TVA-BFN-TS-414 Supplement 1

**BROWNS FERRY NUCLEAR PLANT (BFN) - TVA RESPONSES TO NRC  
REQUESTS FOR ADDITIONAL INFORMATION (RAI) REGARDING UNITS 2  
AND 3 - TECHNICAL SPECIFICATIONS (TS) CHANGE NO. 414 -  
PRESSURE - TEMPERATURE (P-T) CURVE UPDATE**

ENCLOSURE 1  
BFN TS-414 NRC STAFF RAI QUESTIONS/TVA RESPONSES

Figure 3.4.9-1  
Pressure/Temperature Limits

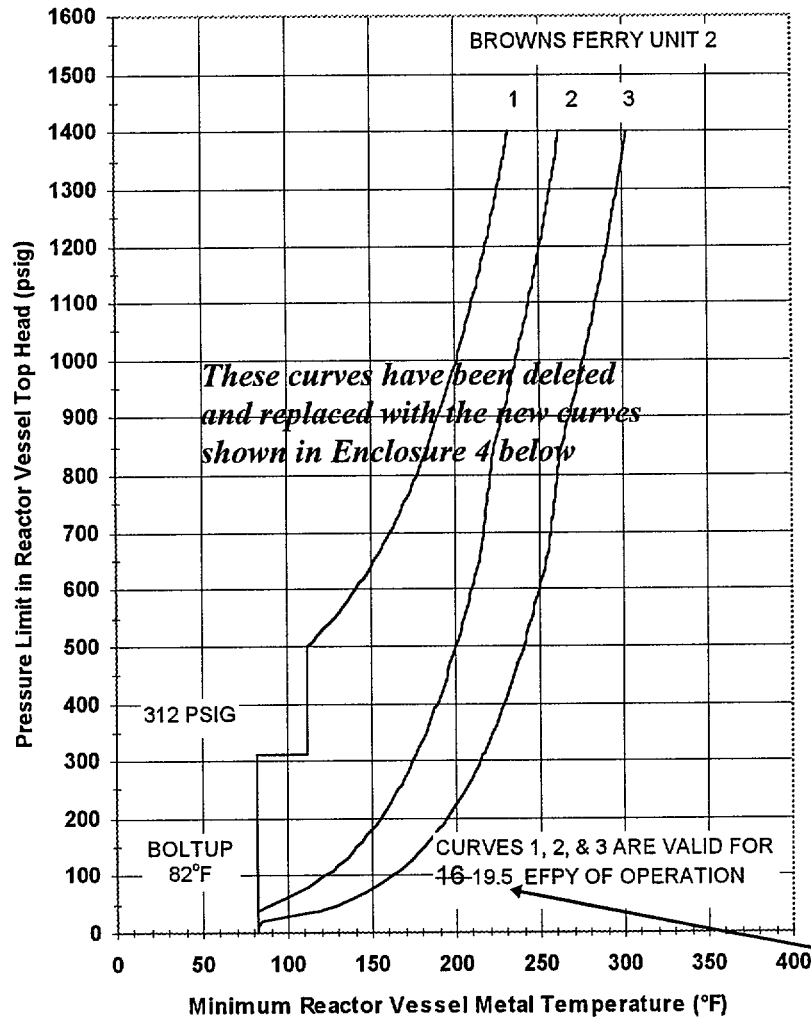
Added "ASME" for additional clarity in this note.

The period of valid use of these curves has been changed from 16 to 19.5 EFY.

Notes  
These curves include sufficient margin to provide protection against feedwater nozzle degradation. The curves allow for shifts in  $RT_{NDT}$  of the Reactor vessel beltline materials, in accordance with Reg. Guide 1.99, Rev. 2, to compensate for radiation embrittlement for 16-19.5 EFY.

**Figure 3.4.9-1**  
**Pressure/Temperature Limits**

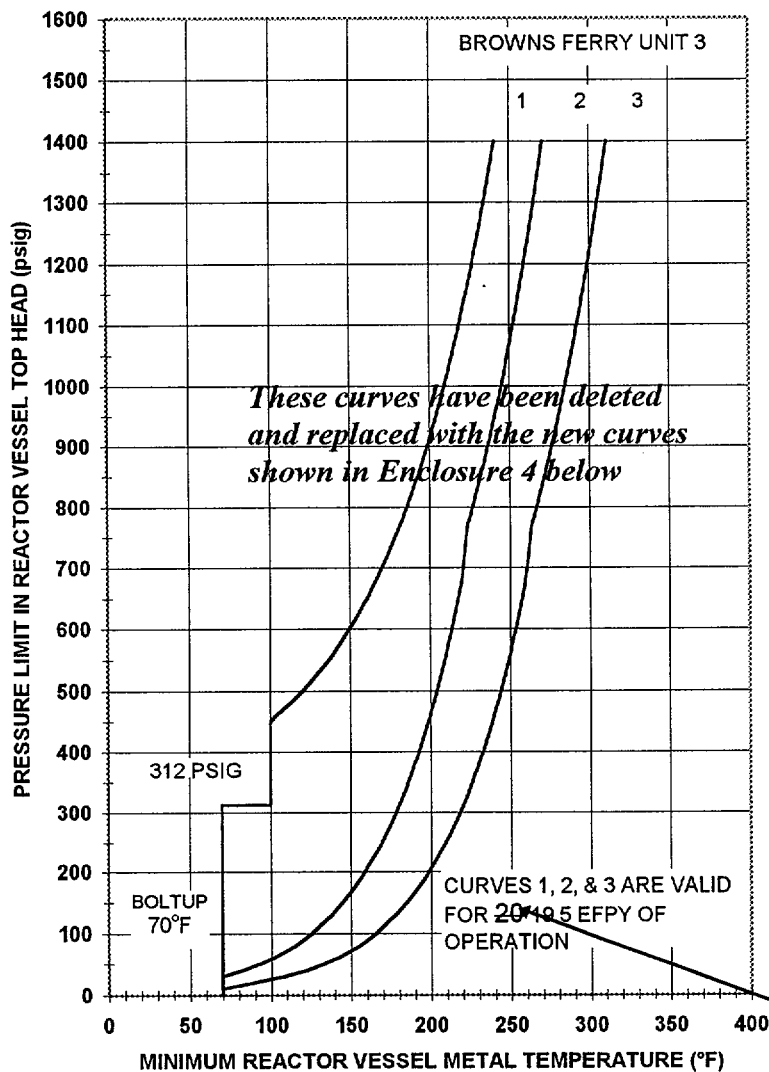
Added "ASME" for additional clarity in this note.

The period of valid use of these curves has been changed from 20 to 19.5 EFY.

These curves include sufficient margin to provide protection against feedwater nozzle degradation. The curves allow for shifts in  $RT_{NDT}$  of the Reactor vessel beltline materials, in accordance with Reg. Guide 1.99, Rev. 2, to compensate for radiation embrittlement for 20 19.5 EFY.

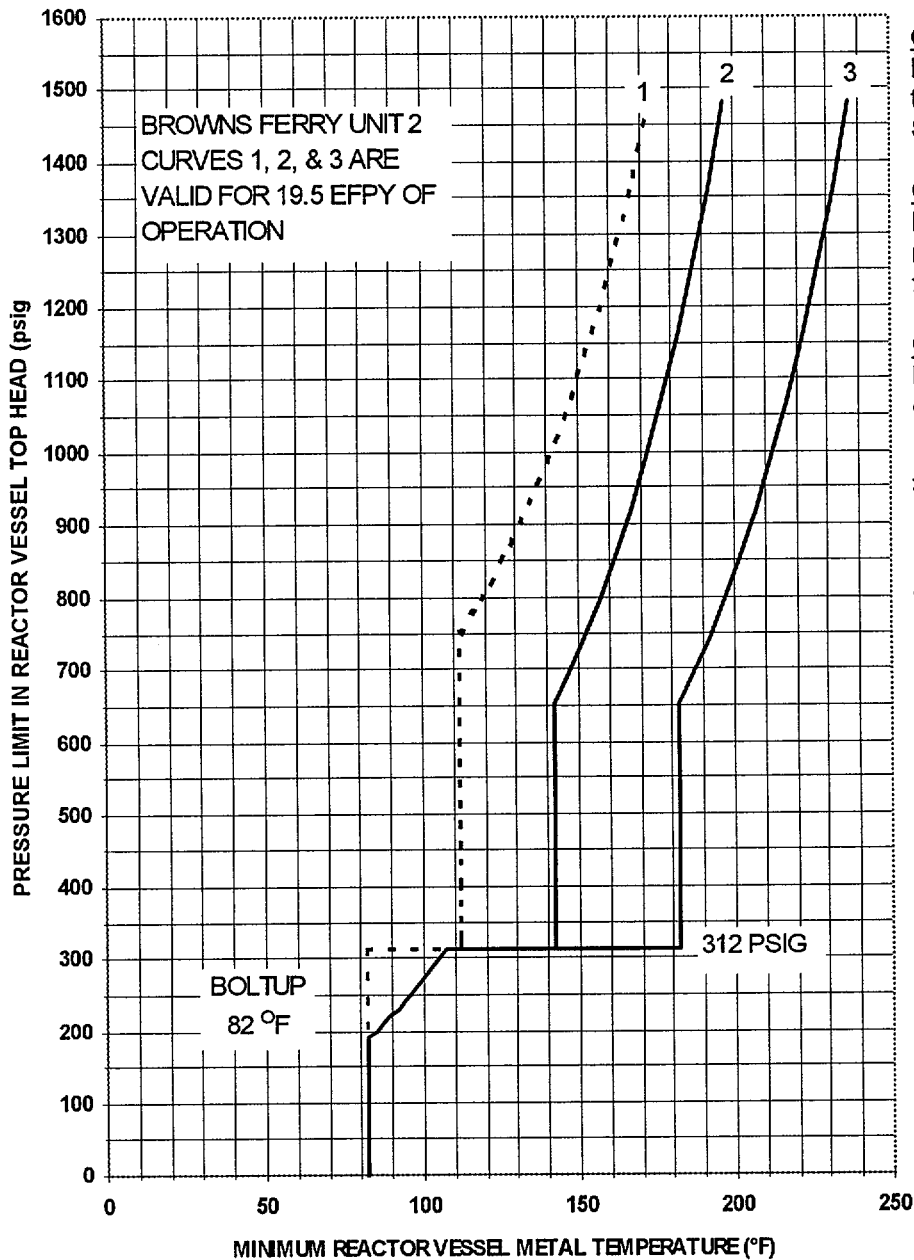
*Note: these figures have been revised from those contained in  
TS-414 due to the change in the limiting ART from  
102.9 °F to 110.6 °F.*

These curves include sufficient margin to provide protection against feedwater nozzle degradation. The curves allow for shifts in  $RT_{NDT}$  of the Reactor vessel beltline materials, in accordance with Reg. Guide 1.99, Rev. 2, to compensate for radiation embrittlement for 19.5 EFPY.
